**Edwin I. Hatch Nuclear Plant  
Third and Fourth 10-Year Interval Inservice Inspection (ISI) Programs  
Submittal to Respond to NRC Request for Additional Information**

**Enclosure 1 - Responses to NRC Request for Information of September 12, 2005**

Enclosure 3  
Southern Nuclear Operating Company (SNC)  
ISI-ALT-1, Version 3.0  
Proposed Alternative in Accordance with 10 CFR 50.55a(a)(3)(i)

FIGURE 1

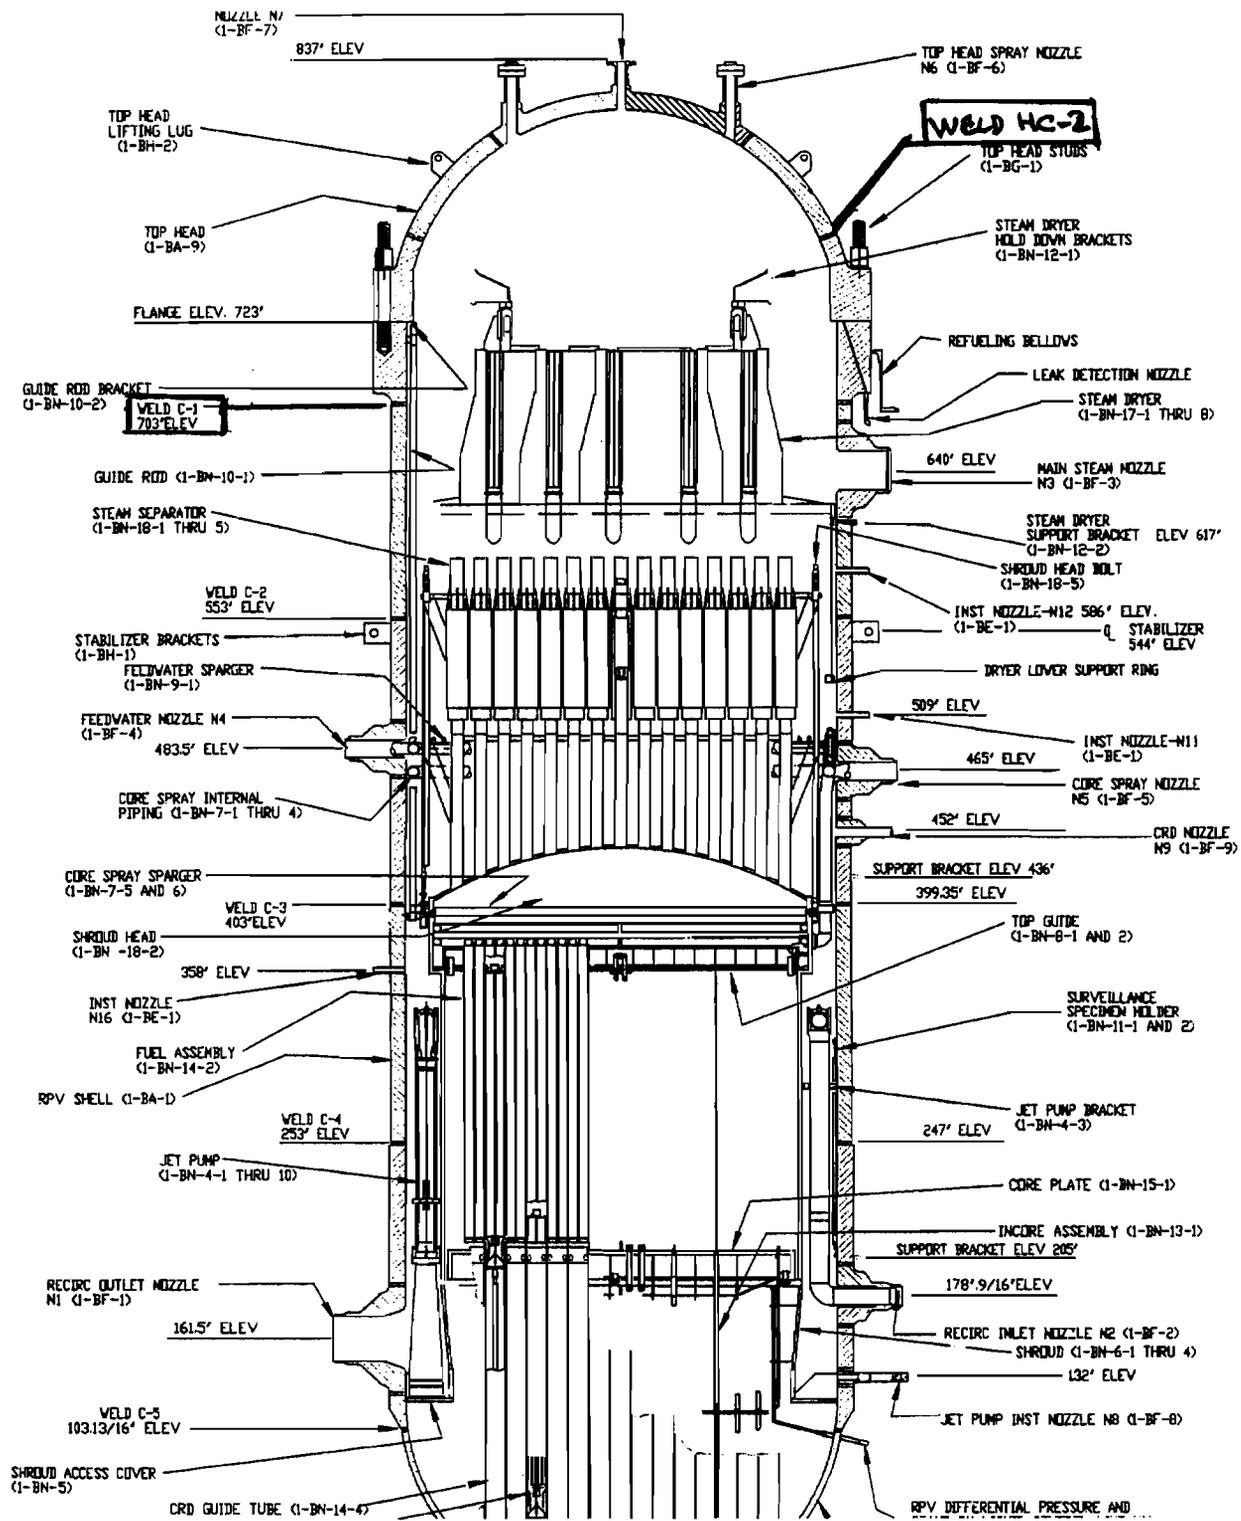
**Limitations** - This examination will be performed from the outside surface of the vessel. The curvature of the flange limits transducer travel such that scanning can only be performed from the shell side of the weld and as shown in Figure 1 (of ISI-ALT-1) the refueling bellows prevents scanning from the upper portion of the flange surface located above the curvature.

Limitations - As shown in Figure 1 (of ISI-ALT-1), the configuration allows scanning from both the head side and the flange side of the weld; however, the short distance from the weld to the flange limits the amount of scanning that can be performed on the flange side of weld.

In lieu of the Article 4 of Section 5 angle beam examination, SNC proposes to use an angle beam examination that will be performed using examination procedures, personnel, and equipment qualified in accordance with Appendix VIII, Supplements 4 and 6, as amended by the conditions set forth in 10 CFR 50.55a. Examination of each weld is described below: (See Figure 1)

FIGURE 2

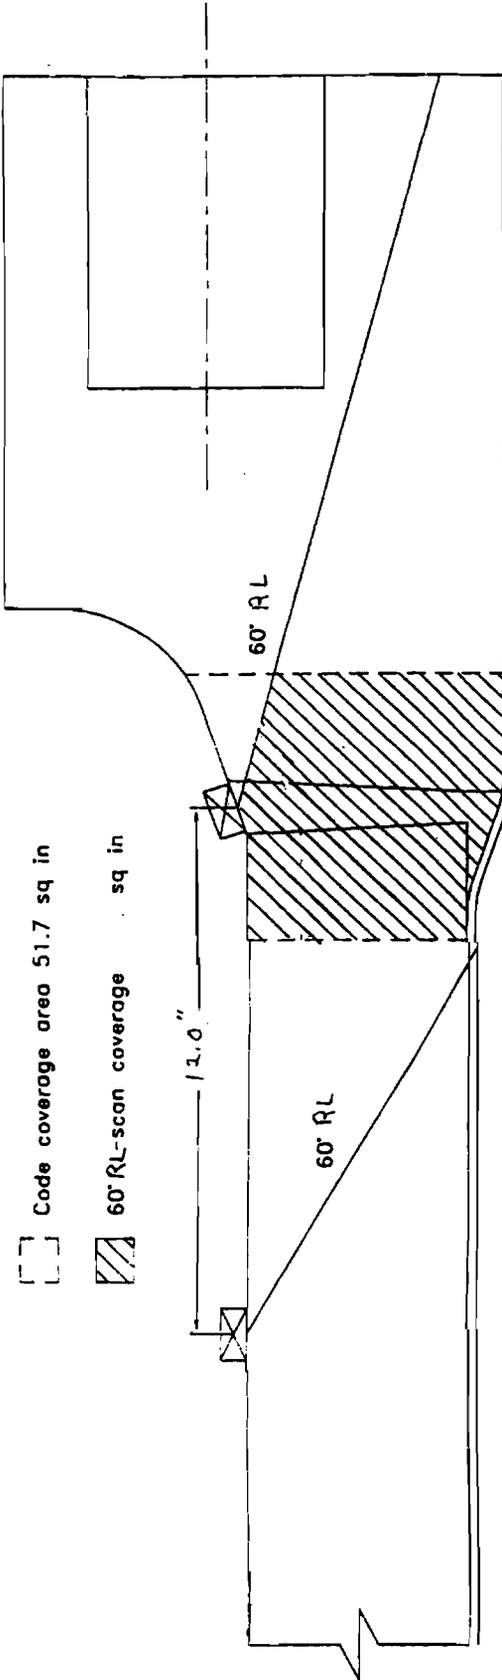
**Examination Requirements** - SNC proposes to use a single side angle beam examination that will be performed using examination procedures, personnel, and equipment qualified through the PDI process in accordance with Appendix VIII, Supplements 4 and 6. Projected coverage for flaws

located parallel to weld is shown in Figure 2 of ISI-ALT-1. Since the examination will be from a single side, the requirements of 10 CFR 50.55a(b)(2)(xvi)(A) apply. Therefore, examinations will be conducted with equipment, procedures, and personnel that have demonstrated proficiency with single side examinations. (To demonstrate equivalency to two sided examinations, the demonstration must be performed to the requirements of Appendix VIII as modified by this paragraph and 10 CFR 50.55a(b)(2)(xv) (B) through (G), on specimens containing flaws with non-optimum sound energy reflecting characteristics or flaws similar to those in the vessel being examined). Scanning will be performed as follows:

The Section XI required examination volume will be scanned for flaws from the outside of the vessel using a 60-degree refracted longitudinal wave; however, the curvature of the flange surface above the weld will limit transducer travel such that examinations can only be performed from the shell side. Additionally, the refueling bellows prevents examinations from being performed from the vertical portion of the flange surface located directly above the curvature. The projected single side coverage for flaws located parallel to the weld is shown in Figure 2.

FIGURE 3

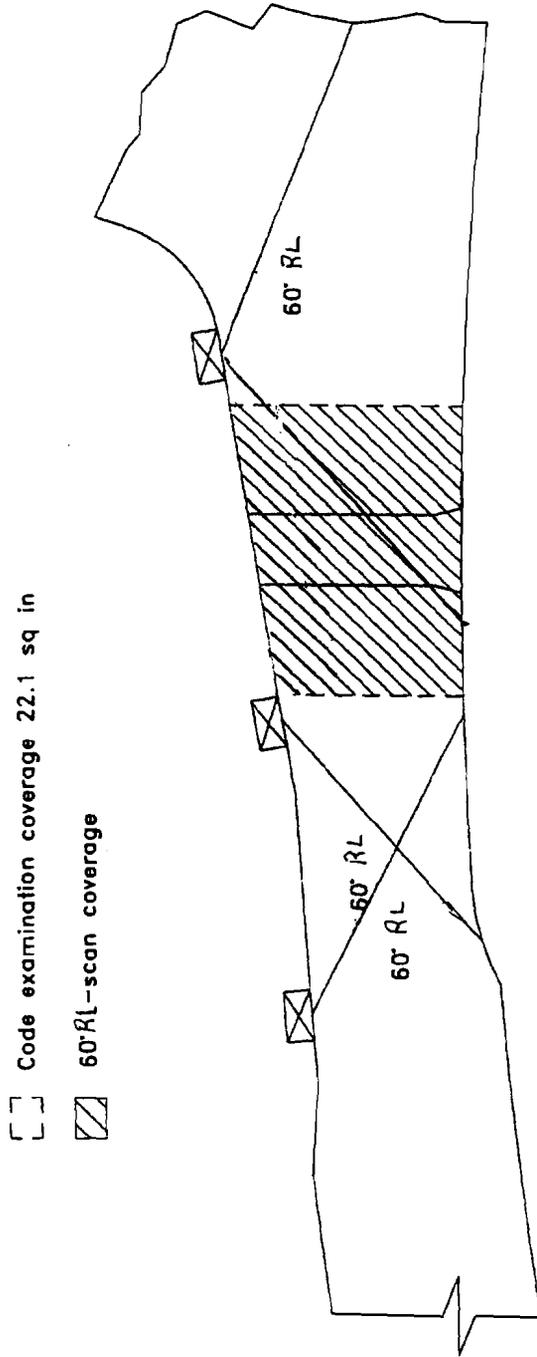
Examination Requirements – The head is not clad; therefore, SNC proposes to use an angle beam examination that will be performed using examination procedures, personnel, and equipment qualified through the PDI process in accordance with Appendix VIII, Supplement 6 as modified by 10 CFR 50.55a(b)(2)(xv)(D), 10 CFR 50.55a(b)(2)(xv)(E), and other applicable paragraphs. Scanning will be performed in four orthogonal directions to the extent practical. Projected coverage for flaws located parallel to weld is shown in Figure 3 of ISI-ALT-1.

The Section XI required examination volume will be scanned for flaws using a 60-degree refracted longitudinal wave. Examinations will be performed from both the head and flange side of the weld; however, the short distance from the weld to the flange limits the examination on the flange side of weld. Scanning will be performed in four orthogonal directions to the extent practical with the projected coverage for flaws located parallel to the weld shown in Figure 3. This weld is not clad; therefore, the examination of the Section XI required volume will be performed using procedures, personnel, and equipment qualified through the PDI process in accordance with Appendix VIII, Supplement 6, as modified by 10 CFR 50.55a(b)(2)(xv)(D), 10 CFR 50.55a(b)(2)(xv)(E), and other applicable paragraphs.
